ADDENDUM

PROJECT: Forestside Estates
Attmar & Palleschi Drive
Brampton, Ontario

ADDENDUM NO. M-2

PURPOSE: To match Architectural changes and coordination as discussed on coordination meeting.

02	RC	ADDENDUM #02	SEP. 13, 2019
01	RC	ISSUED FOR TENDER	AUG. 02, 2019
NO.	BY	DESCRIPTION	DATE

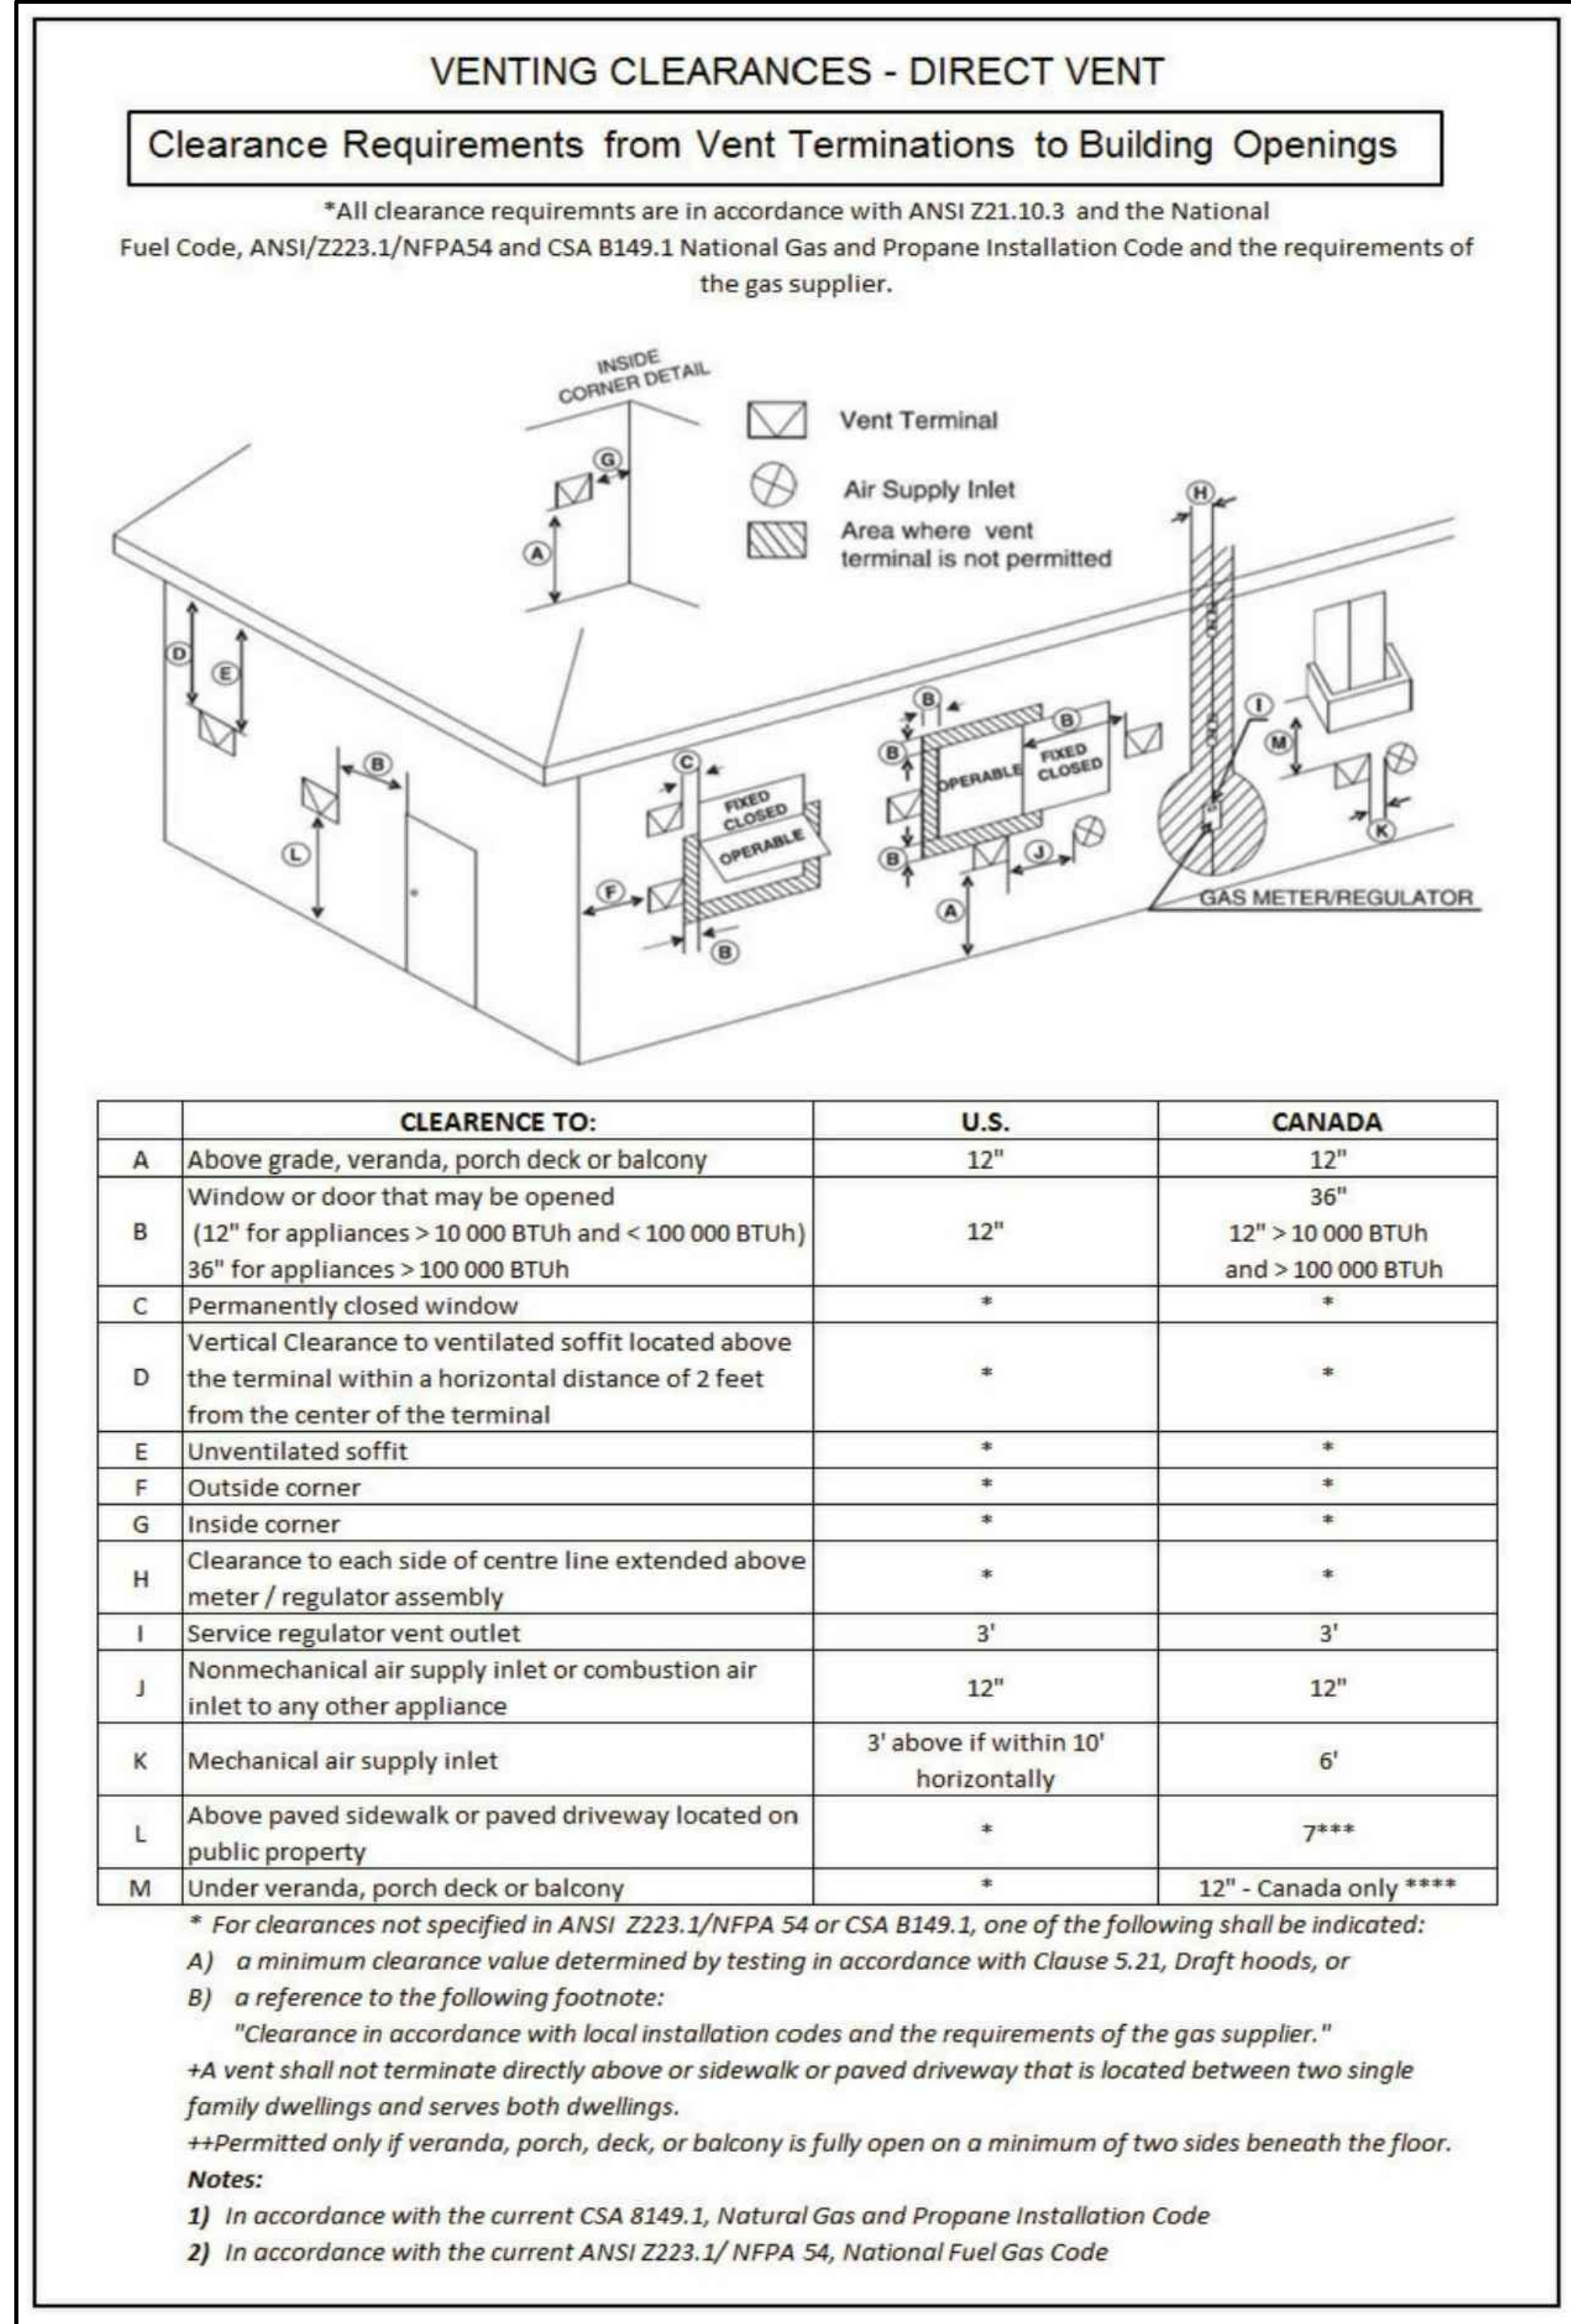
12.0 Mechanical drawing M-47 ((Typical Suites Layout - Mechanical) Issued

12.1 Revised: Ductwork and diffuser layouts as indicated.
